Number 0.7.

Section Heating & Windscreen
Washing Equipment.

INTRODUCTION OF THE LUCAS 5SJ SCREEN JET WINDSCREEN WASHER.

DRAIN HOLES IN NEW TYPE REAR LAMPS

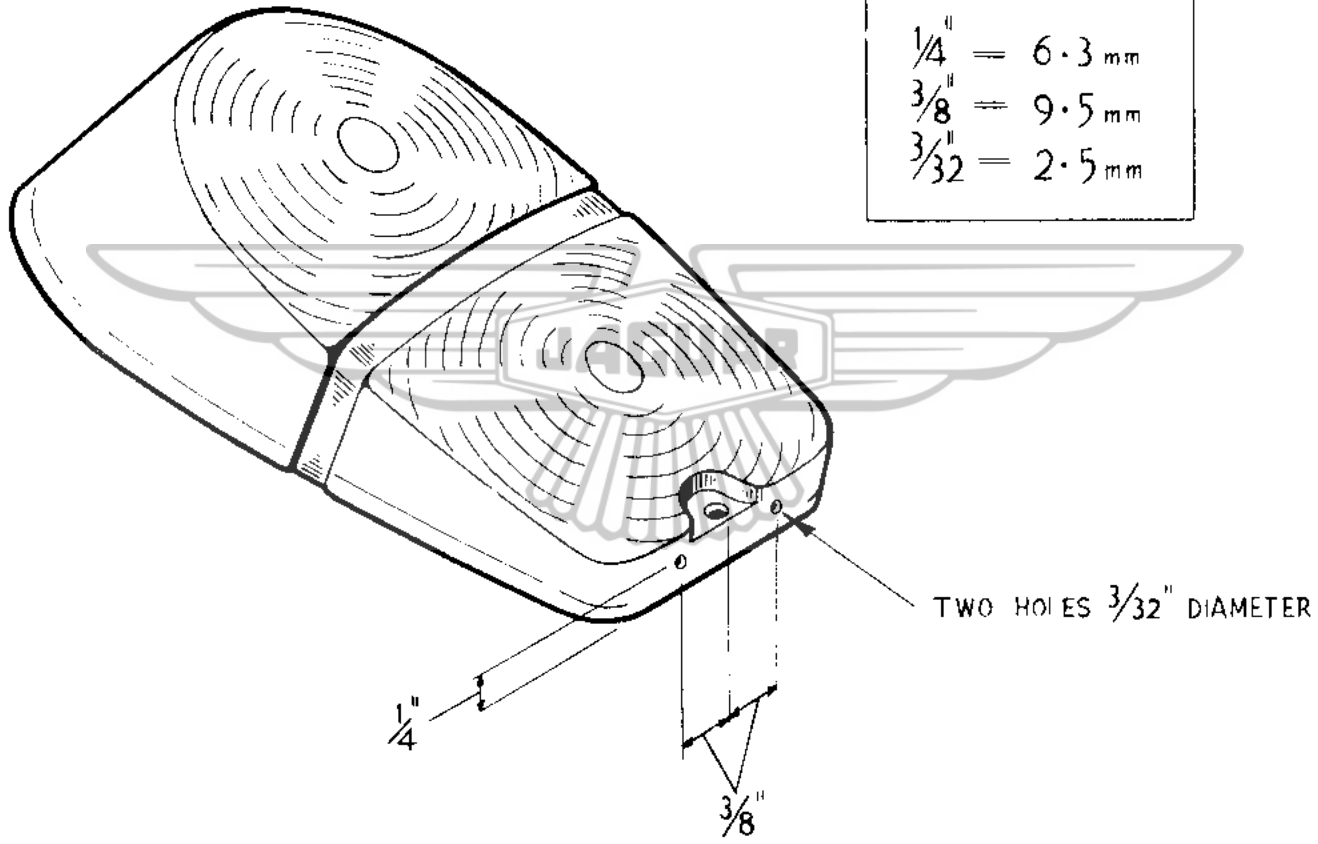
A certain number of 1960 cars with the new type rear lamps (with separate flasher and tail light bulbs) were sent out of the factory without the drain holes in the bottom of the lamp lens.

Cars in stock or cars coming in for servicing should be checked for having two holes drilled in the bottom of the rear lamp lens. If not so drilled, two holes should be made in the bottom of the lens as shown in the sketch overleaf.

FIG 2

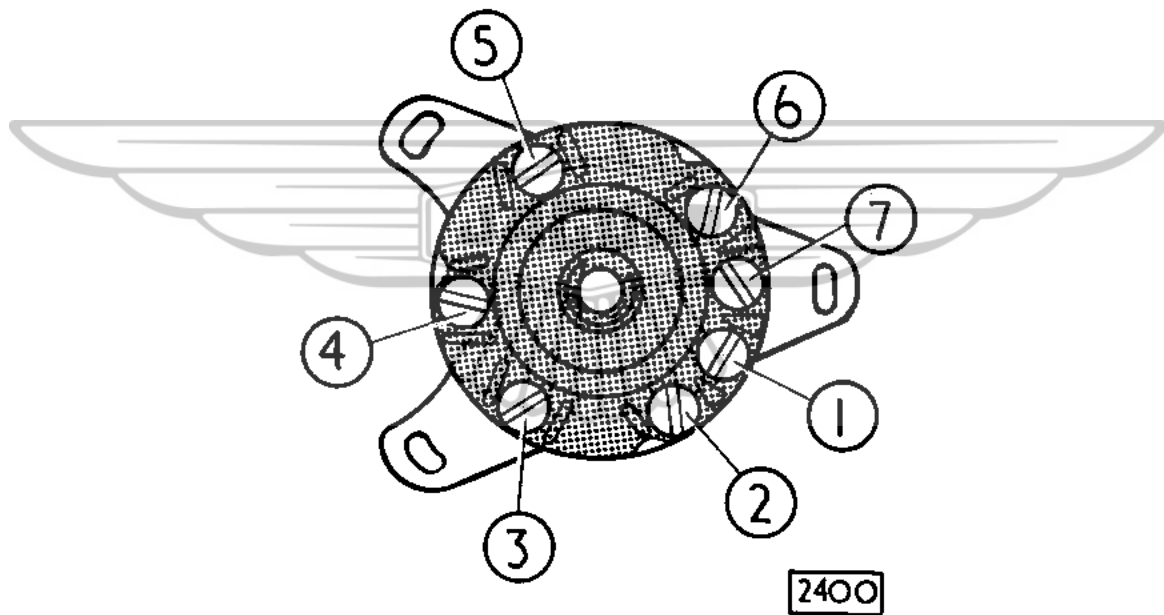
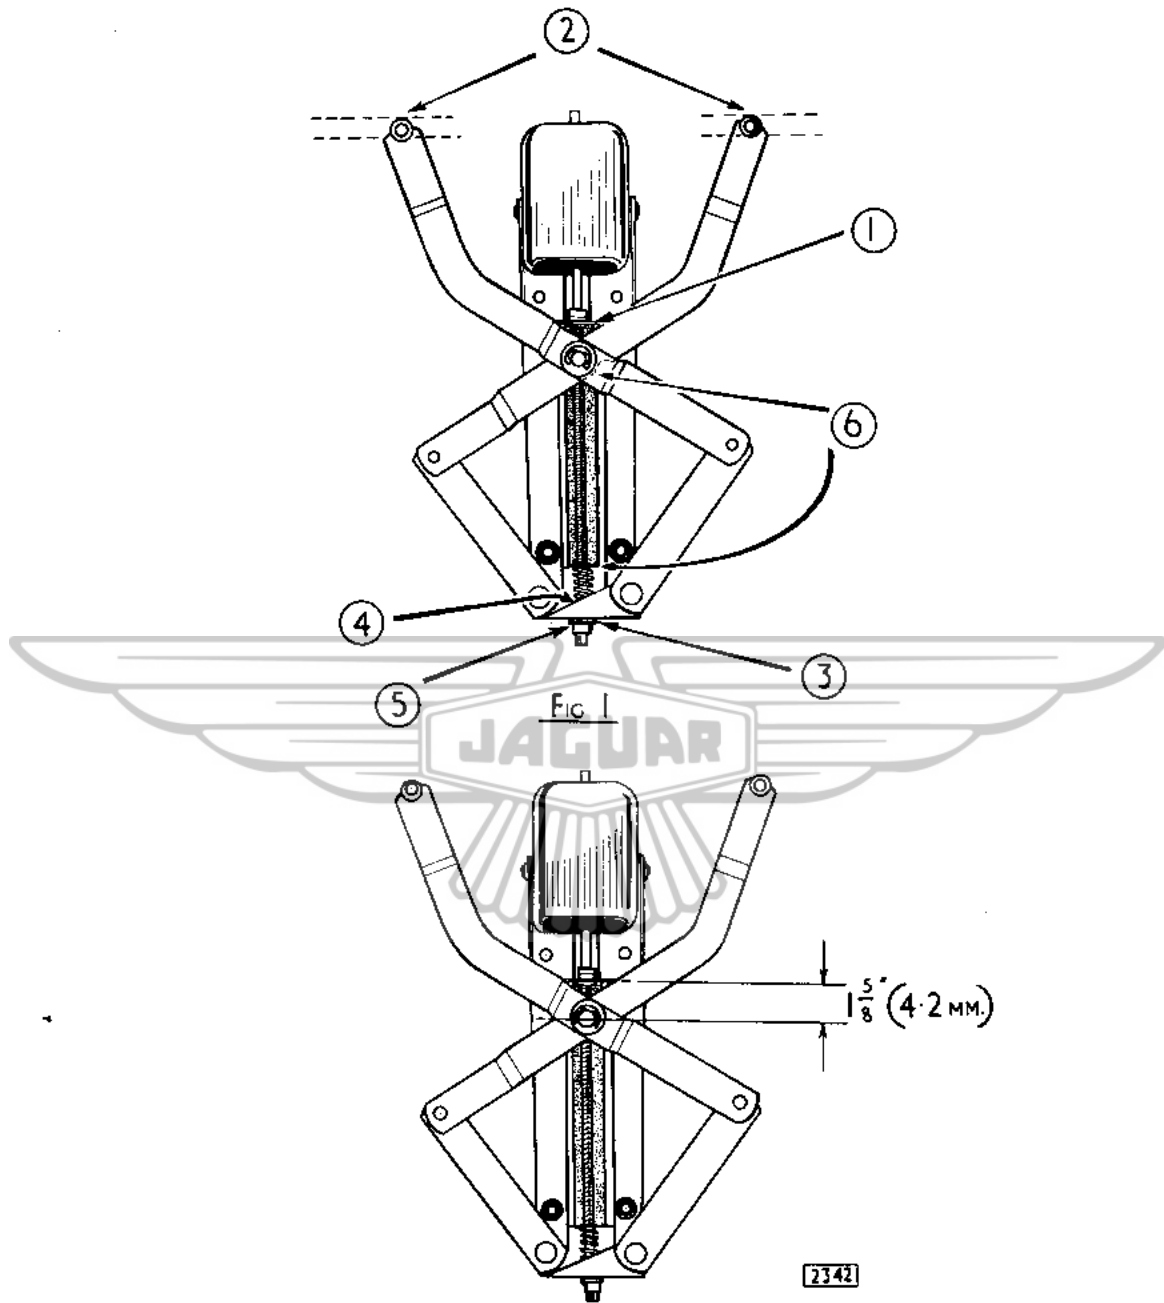
Replace the cables as shown in Fig.2. and connect the red/yellow cables, incorporated in the harness, to the foglamp terminal.

The amended wiring circuits are shown overleaf.

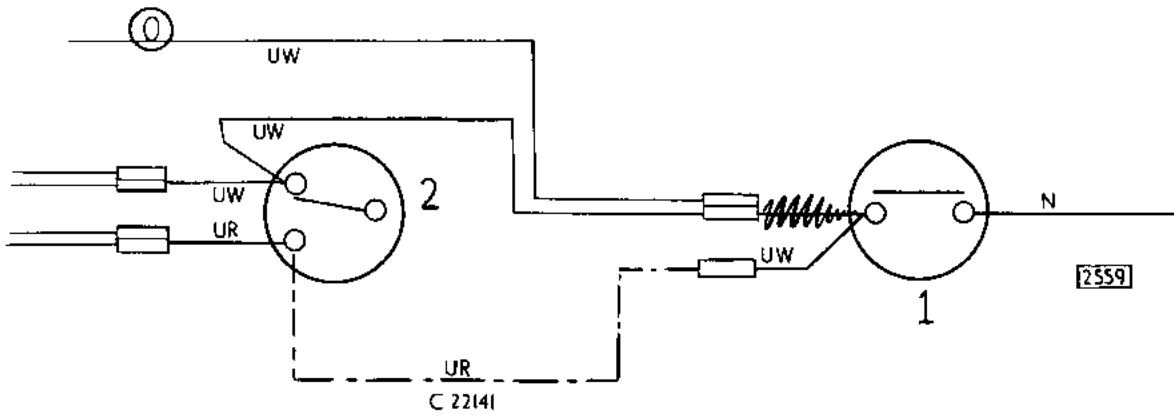
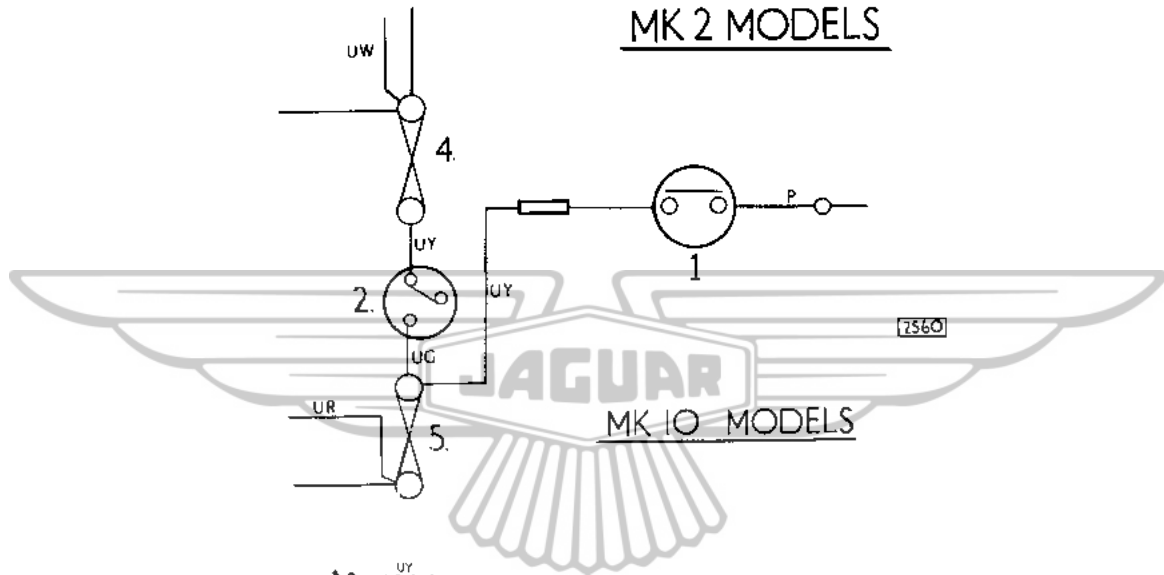
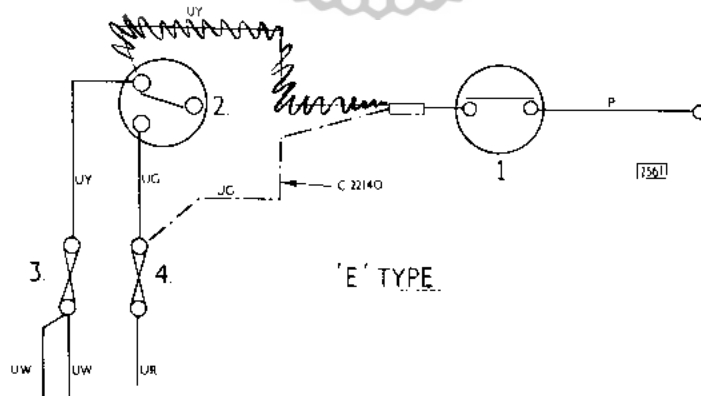
Commencing at the above chassis numbers, all cars for the Italian market will have the headlights wired to "flash" when the lights are "off" or when they are in the main beam position: They will not "flash" in the dipped position.

INTRODUCTION OF MODIFIED DISTRIBUTOR.

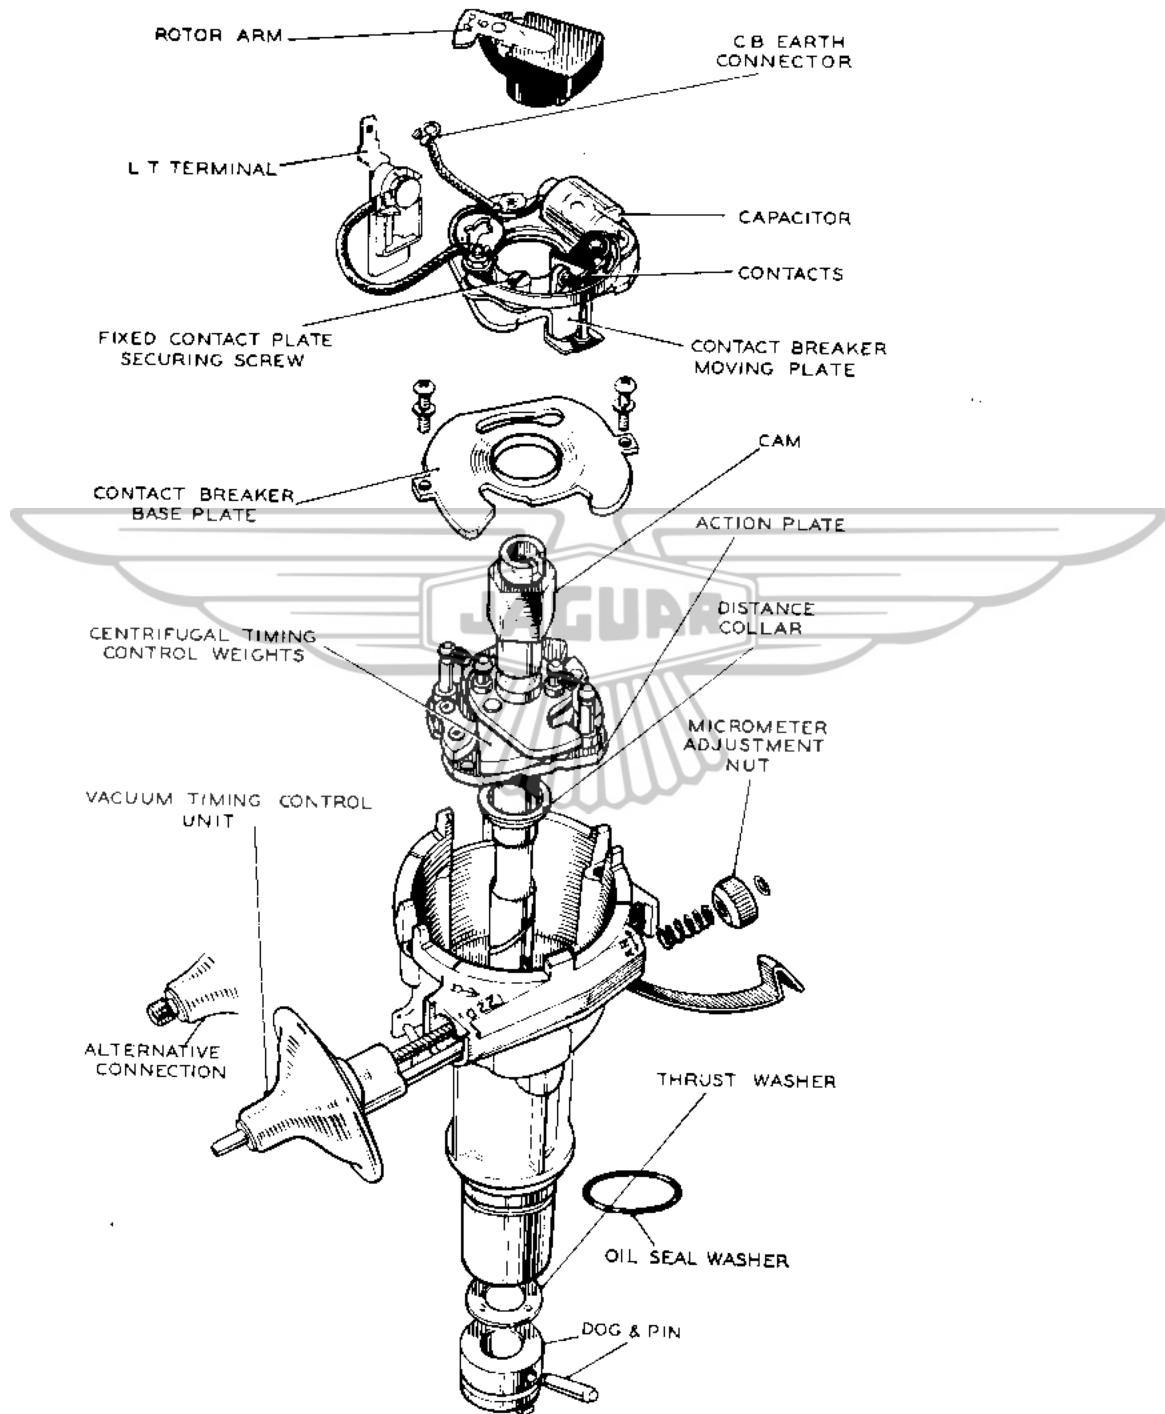
All current production cars are now fitted with a new 22D6 type distributor. (illustrated overleaf)

This type of distributor is different in construction to the previous DMBZ6 type fitted but the advance curves remain the same.

The new type distributors are interchangeable with their appropriate predecessors provided a new type suction pipe is fitted.

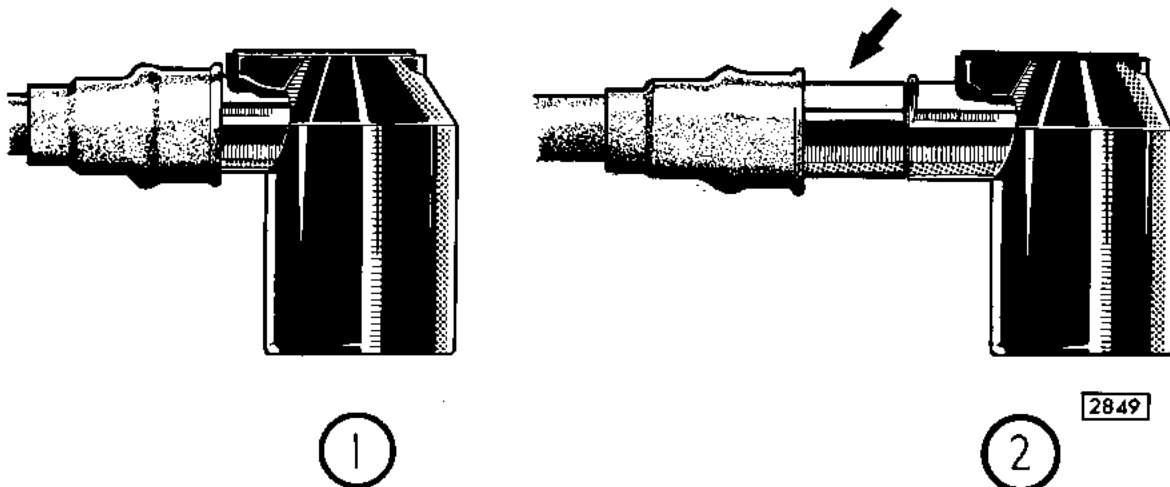
Fig.1 shows a sparking plug terminal without a suppressor fitted. Fig.2 shows the sparking plug terminal with suppressor fitted.

Distributors and dealers are requested to examine all cars coming in for service and check if suppressors are fitted. If suppressors are not fitted on cars within the guarantee period these must be fitted on a f.o.c basis to the customer.

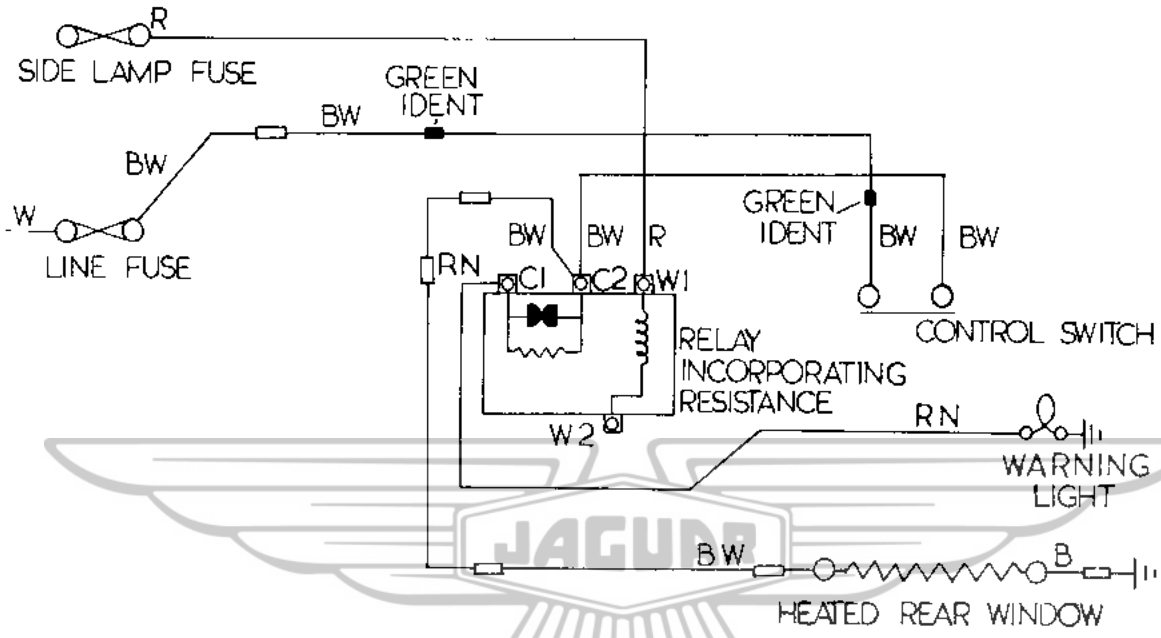
Commencing at the above chassis numbers the Heated Backlight has a control switch, warning light and relay with resistance included in the electrical circuit.

The warning light, operating through the resistance, is dimmed when the side lights are switched on.

The circuit remains ignition controlled and there is no change in the fuse rating, fuse location and the current consumption.

IGNITION SWITCH - AIR CONDITIONED CARS

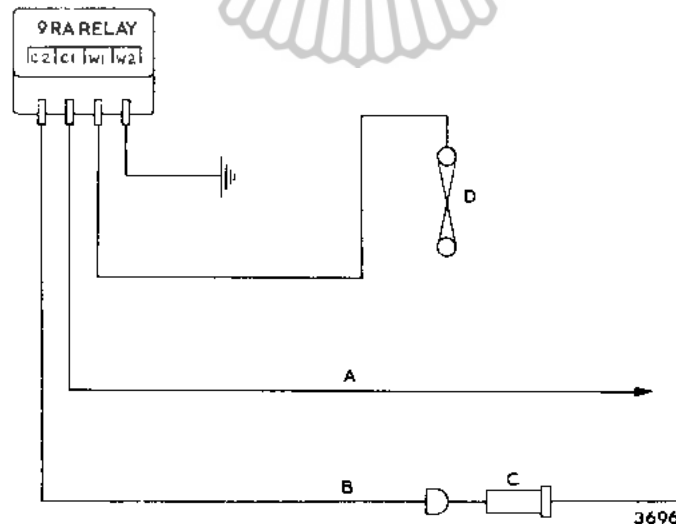
Isolated instances have occurred of ignition switch failure on cars fitted with an Air Conditioning System.

To prevent this fault recurring, a Lucas 9 RA Relay (Part No. C.19085) has been introduced into the Air Conditioning Electrical circuit on current production cars, the revised circuit being as illustrated.

If complaints are received of ignition switch failure, it is recommended that the relay is fitted in a convenient position and the circuit modified. The main output terminal (A) should have a 35 amp terminal fitted to connect to the alternator.
